Takes of Marine Mammals Incidental to Specified Activities; Marine Geophysical Survey in the Northwest Atlantic Ocean Offshore North Carolina, September to October, 2014

ACTION: Notice; issuance of an incidental harassment authorization.

SUMMARY: In accordance with the Marine Mammal Protection Act (MMPA) implementing regulations, we hereby give notice that we have issued an Incidental Harassment Authorization (Authorization) to Lamont-Doherty Earth Observatory (Lamont-Doherty) a component of Columbia University, in collaboration with the National Science Foundation (Foundation), to take marine mammals, by harassment, incidental to conducting a marine geophysical (seismic) survey in the northwest Atlantic Ocean off the North Carolina coast from September 15 through October 31, 2014.

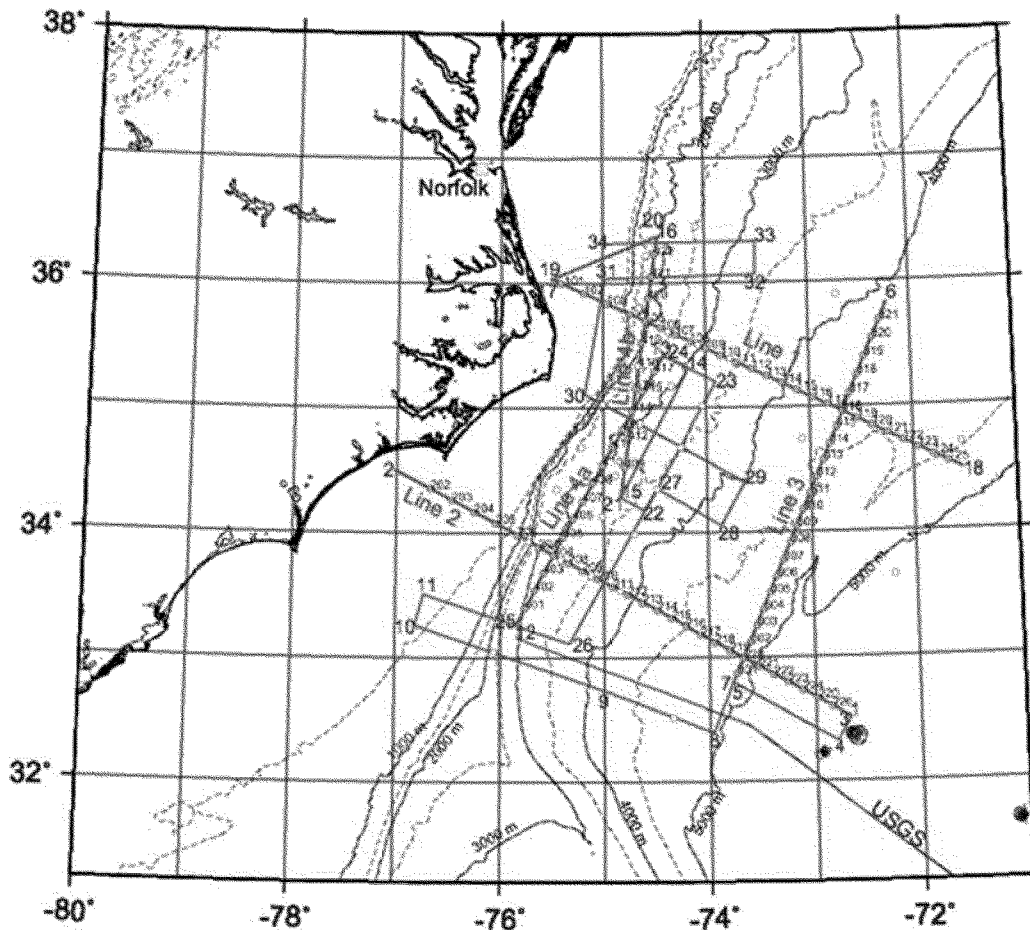
Comment 4: The Commission described our proposed requirement for the *Langseth* to conduct the survey (especially when near land) from the coast (inshore) and proceed towards the sea (offshore) to the maximum extent possible. The Commission agrees with this requirement, but recommends that we remove the qualifying phrase ". . . to the maximum extent practicable . . ." within the Authorization.

Comment 15: NRDC *et al.* states that Lamont-Doherty provides no justification for the particular trackline configuration (see Addendum) and why that design elected to remove the 25 percent contingency that it typically adds to its tracklines, as opposed to other potential designs represents the least practical adverse impact on marine mammals. They further state that we should limit Lamont-Doherty to both the specified tracklines and the specified number of line-kilometers, and require cessation of the activity when they reach the latter.

Response: Lamont-Doherty has planned the survey to comply with the requirement to conduct acquisition activities from the coast in a seaward direction to the maximum extent practicable. However, this requirement may not be practicable in all situations. In a few cases, Lamont-Doherty must acquire data (see Lines 1 and Lines 2 in Figure 1 in this notice) transiting

towards the coast to meet their research goals such as when switching from an OBS line to a MCS line. We have evaluated the commenter's recommendation and Lamont-Doherty's reasons for why the measure may (or may not) be practicable and have concluded that after taking into consideration the project's purpose, there is no practicable alternative for Lamont-Doherty's proposed acquisition activities. Thus, for this Authorization we will not remove the qualifying phrase to the maximum extent practicable.

We have revised the take estimates to account for the 10 tracklines that would require repeat coverage. The Authorization accounts for the modified number of tracklines (including repeated tracklines) shown in Figure 1 in this notice. We note that unlike previous seismic surveys aboard the *Langseth*, Lamont-Doherty would conduct the 2-D survey as almost one continuous line. Therefore, the ensonified area for the seismic survey does not include a contingency factor (typically increased by 25 percent to accommodate turns and equipment testing, etc.) in line-kilometers. Also, any marine mammal sightings within or near the designated exclusion zones will
